NOTICE OF NON-PERFORMANCE

INSPECTION REPORT

Electrical Corporation:	PacifiCorp
Report Number:	PAD_PC_RMA_20251007_1132
Inspector:	Romeo Marroquin Ajcac
WMP Year Inspected:	2025
Quarterly Data Report (QDR) Referenced:	Quarter 2 (Q2)
Inspection Selection:	Energy Safety viewed the contents of the Q2 QDR and performed an analysis that resulted in the selection of the WMP initiatives and locations referenced in this report.
Relevant WMP Initiative(s):	8.1.2.12 - Expulsion Fuse Replacements
Date of inspection:	October 7, 2025
City and/or County of Inspection:	Yreka, Siskiyou County
Inspection Purpose:	Assess the accuracy of PacifiCorp's QDR data, completeness of its work, and performance of WMP requirements.

GImg1: Overall Structure	GImg2: Structure ID

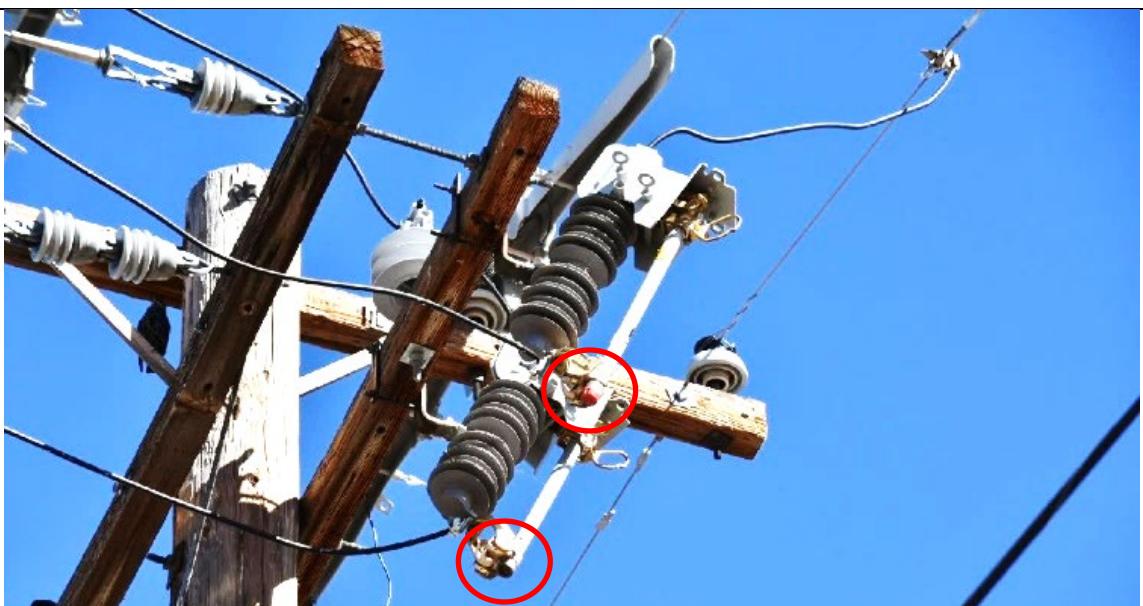
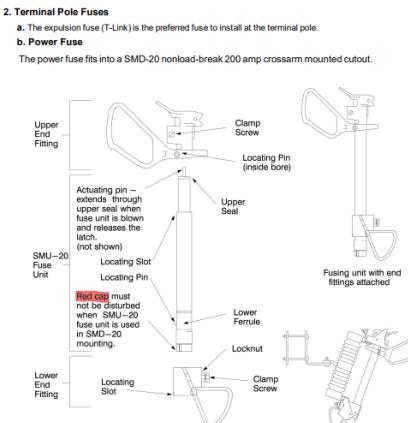
On Pole ID 624507.367802, Grid Hardening ID 7112939 at Sanitary Landfill Rd, Yreka, CA, 96097, USA, 41.71141544174789, -122.598414, the inspector observed that one of the installed CAL FIRE-approved non-expulsion fuses was missing its red cap. The inspector's observation is documented in Deficiency 1 photographs, which are attached to this report. Photo number IA1Img1 depicts a CAL FIRE-approved non-expulsion fuse missing its red cap. Additionally, photo numbers Item1B1Img1 and Item1B1Img2 depict PC construction standards, which clarify that CAL FIRE-approved non-expulsion SMU-20 fuses, such as the one observed by the inspector at the inspection location, must have its red cap intact and in place when installed in an SMD-20 mounting. In the 2025 Q2 Quarterly Data Report submission, PC reported that work on WMP initiative 8.1.2.12 – Expulsion Fuse Replacements was complete at this location.

IA1Img1: CAL FIRE-approved non expulsion fuse with a missing red cap (bottom left) and second CAL FIRE-approved non expulsion fuse with red cap attached (upper right).

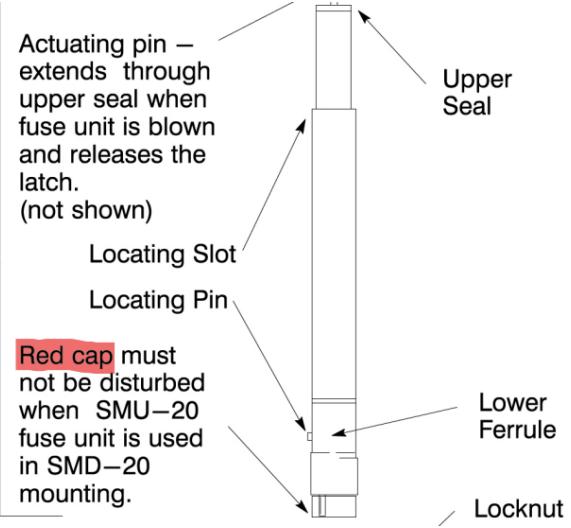
1. One of the CAL FIRE-approved non-expulsion SMU-20 fuses was missing its red cap.
2. PC's construction standards for CAL FIRE-approved non-expulsion SMU-20 fuses require the presence of a red cap when installed in SMD-20 mounting.

Deficiency 1. Energy Safety observed that in implementing the 2025 WMP initiative 8.1.2.12 – Expulsion Fuse Replacements, PC failed to complete the installation of CAL FIRE-approved non-expulsion fuses on Pole ID 624507.367802, Grid Hardening ID 7112939 at coordinates 41.71141544174789, -122.598414. Energy Safety considers this non-performance to be in the Minor risk category. PC must complete a corrective action for this deficiency by 12 months of this notice.¹
